Re: Minor Project Refinement No. 17 for the South Orange County Reliability Enhancement Project.

South Orange County Reliability Enhancement Project CPUC Minor Project Refinement Form

Date Requested: April 25, 2023			Report No.: 17			
Date Approved: Ma	ay 4, 2023		Approval Agency: California Public Utilities Commission (CPUC).			
17 (MPR-17) tempor the SDG&E right-of Camp Pendleton (M	: The Minor Project Forary work areas are -way (ROW) on Marin MCBCP) property. The is located outside	located within ne Corps Base on northern half	Location/Milepost : The MPR-17 temporary work areas are located south of Avenida Pico and west of the Talega Substation in San Diego County.			
 Land Use/Vegetative Cover: The land use and vegetative cover for the proposed MPR-17 work areas is estimated as follows: Stringing Site Additional Work Area (WASS) (west of location 2B work area) – 4,998 sf (0.11 acre) in disturbed. Location 16A Additional Work Area (WA16) (east of Location 16A Work Area) – 1,099 sf (0.03 acre) in disturbed. Access Road Work Area (AR43) (west of Location 43 Work Area) – 283 sf (0.01 acre) in disturbed. 			Sensitive Resources: The MPR-17 work areas are located in an area with und

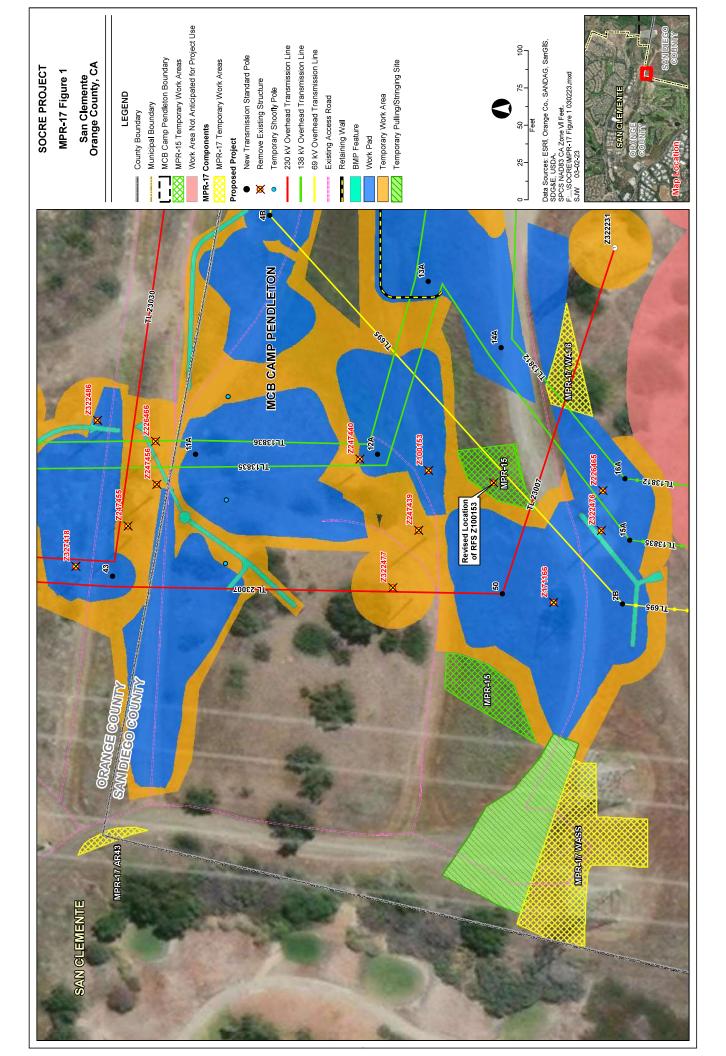
San Diego Gas and Electric (SDG&E) is requesting approval of MPR-17 for three new temporary work areas for the South Orange County Reliability Enhancement Project (SOCRE or Project). The new temporary work areas are contiguous with previously approved project components as shown in **Attachment B, MPR-17 Figure**. The new MPR-17 work areas will total approximately 6,380 square feet (0.15 acre).

The AR43 temporary work area contains vegetation that is currently encroaching into the access road. AR43 activities will include mowing vegetation within the work area to accommodate larger deliveries along the access road and for fire mitigation. No ground disturbance is anticipated. **Attachment B, MPR-17 Figure** shows the locations of the MPR-17 temporary work areas.

-COA-1. The extent of the MPR-17 disturbance areas will be limited to the areas shown on the figure titled "SOCRE PROJECT MPR-17 Figure 1" and will be used for project construction staging and related activities only during the period of project construction and restoration (anticipated to be approximately through the first quarter of 2025).
